CITY OF ALBUQUERQUE

RE: **13424 Cedarbrook Ave NE**
Request for Pad Certification – Not Accepted
Grading Plan Stamp Date: 11/27/18
Certification Dated: 12/3/18
Drainage File: F23D013

DRAINAGE AND TRANSPORTATION INFORMATION SHEET (REV 6/2018)

<div>ENGINEER'S SEAL</div> <div>DAVID SOULE NEW MEXICO REGISTERED PROFESSIONAL ENGINEER (14522)</div> <div>11/27/18</div> <div>DAVID SOULE P.E. #14522</div>	13424 CEDARBROOK AVE.	DRAWN BY DEM
	GRADING AND DRAINAGE PLAN	DATE 9-23-2018
	<div></div> <div>Rio Grande Engineering 1800 CENTRAL AVENUE SUITE 301 ALBUQUERQUE, NM 87108 (505) 872-0000</div>	SHEET # 1 OF 1 JOB # XXXXX

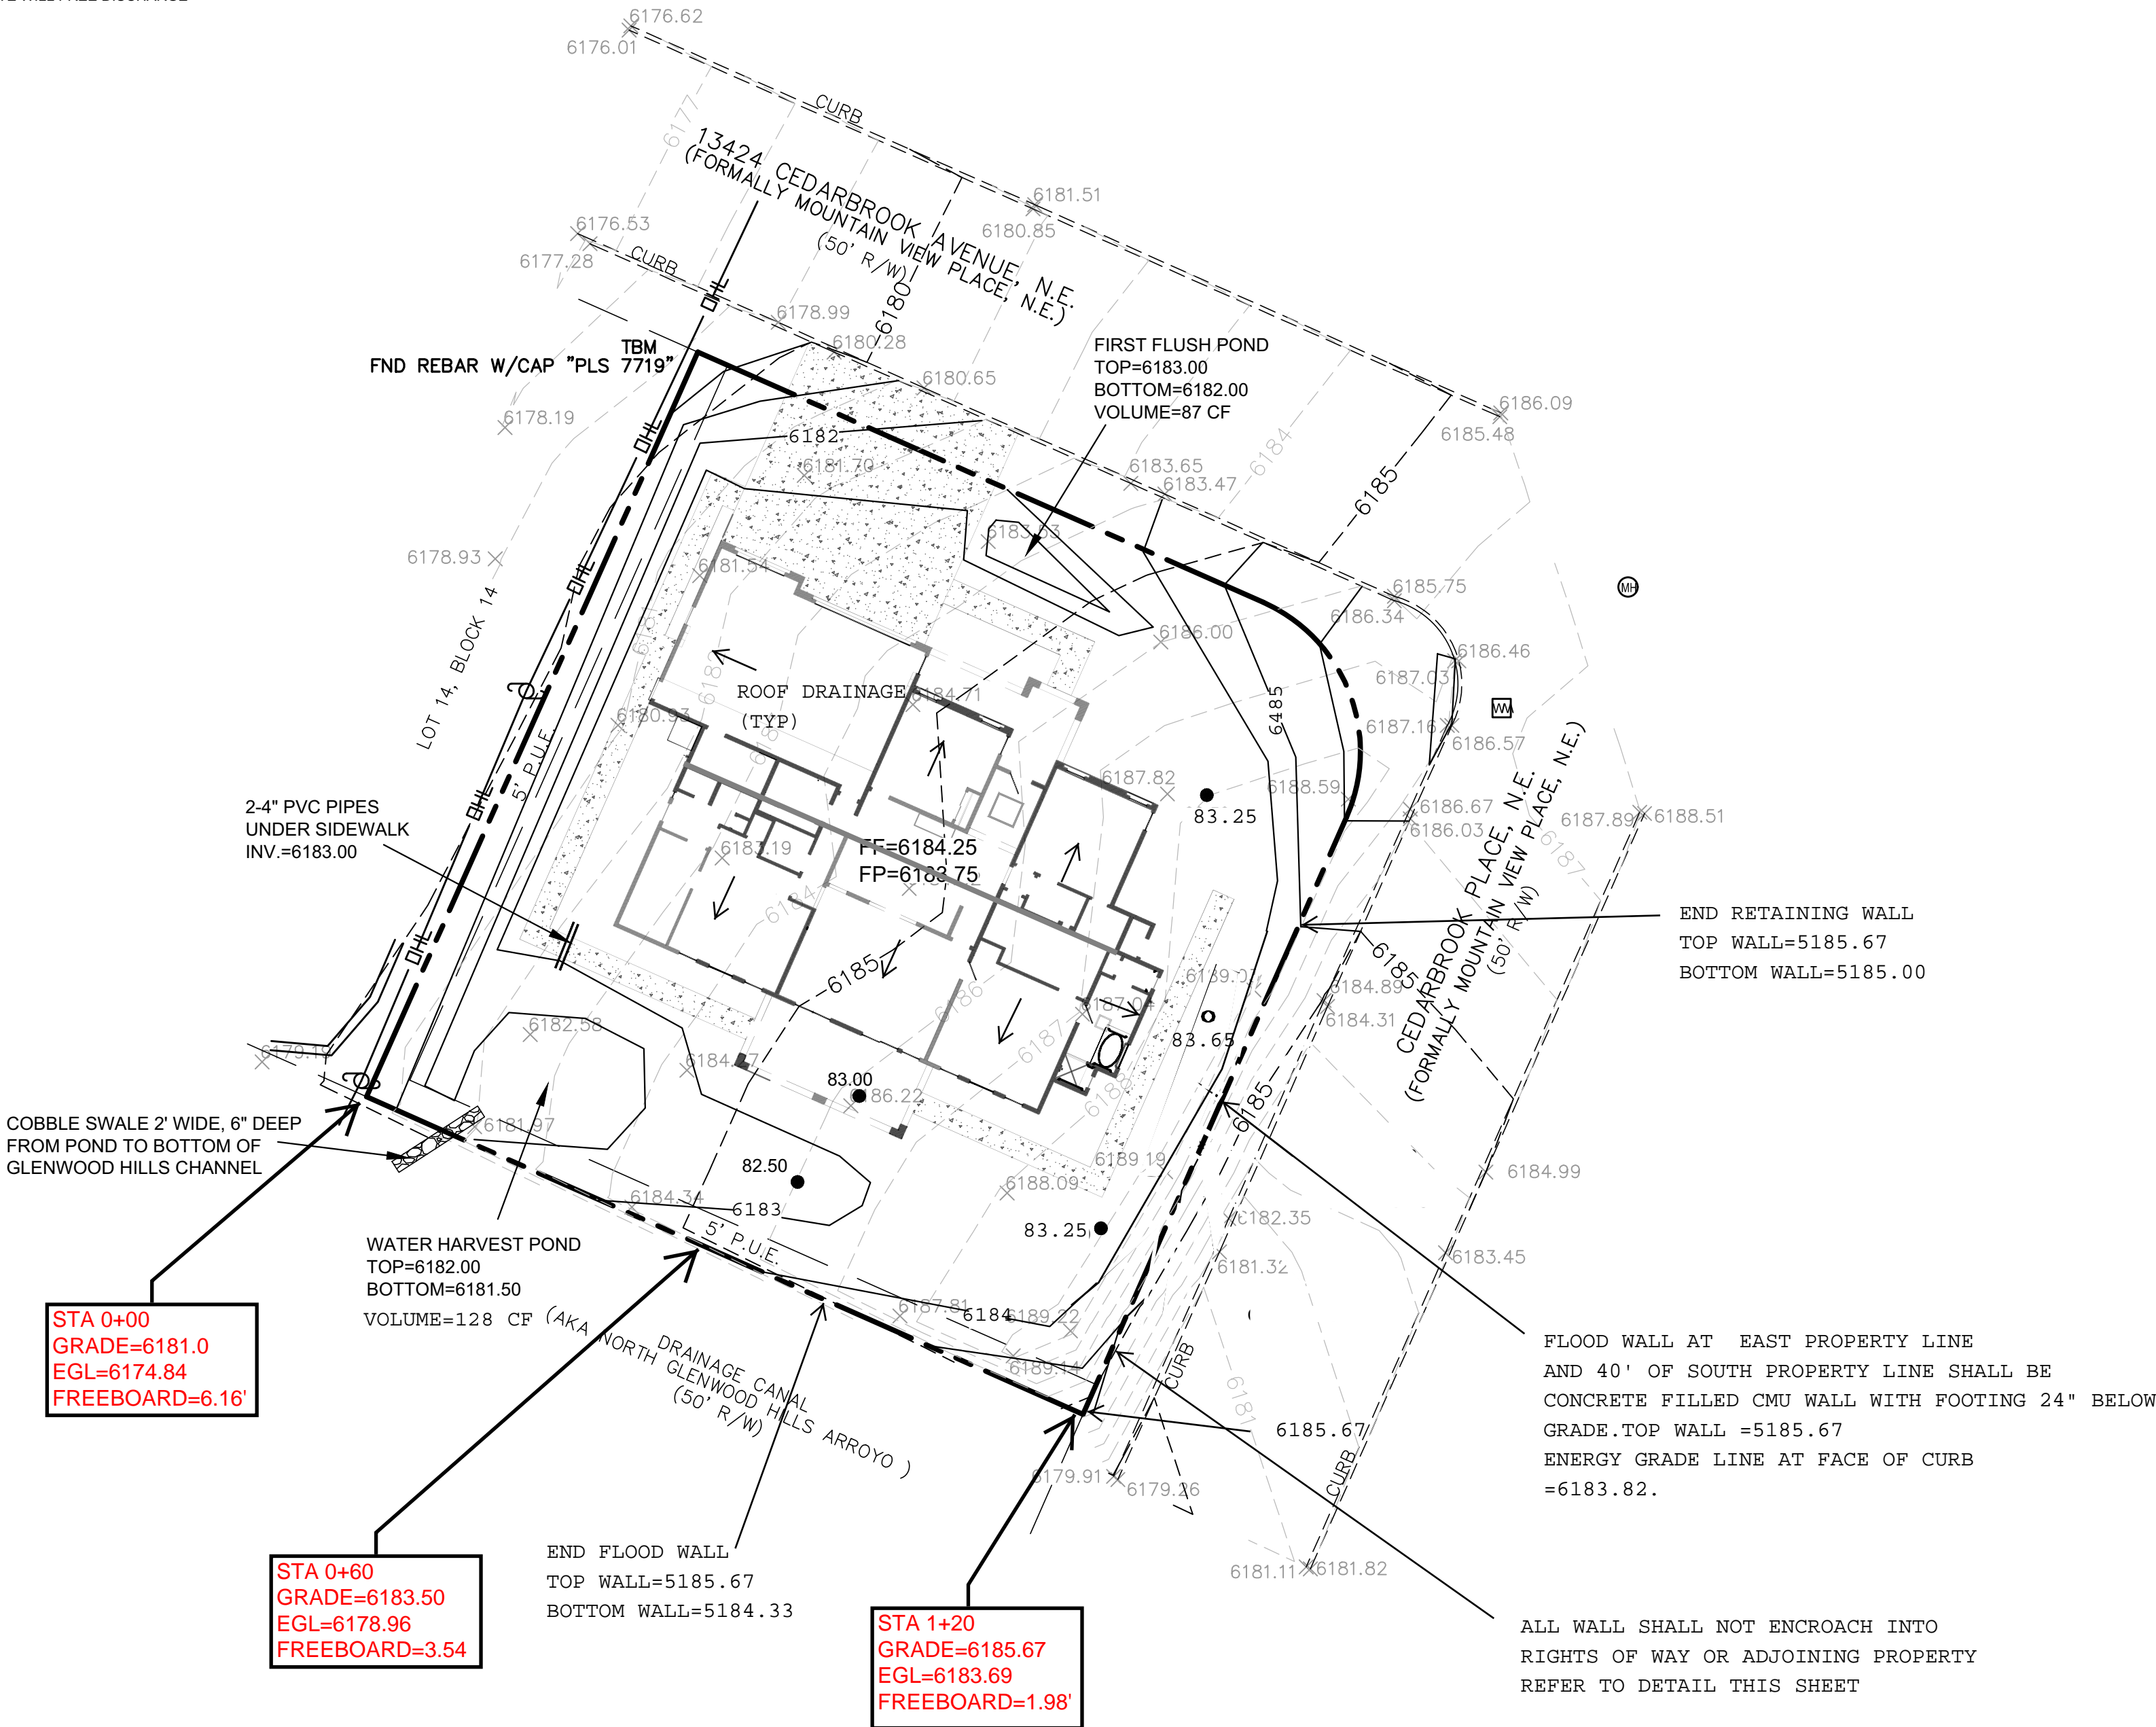
Based on the submittal received on 12/3/18, the Engineer's Certification cannot be approved for Building Permit until the following are corrected:

1. Survey the building pad, east and south property lines and provide the surveyed elevations on the Grading Plan.
2. Complete the grading along the east property line and the southeast corner and prepare the subgrade for freeboard wall construction; do not leave the cut-bank at property line, do not grade into the arroyo ROW.

3. Engineer's Certification, per the DPM Chapter 22.7: *Engineer's Certification Checklist For Non-Subdivision* is required to ensure the site and the grades along the property lines were not disturbed during home construction.
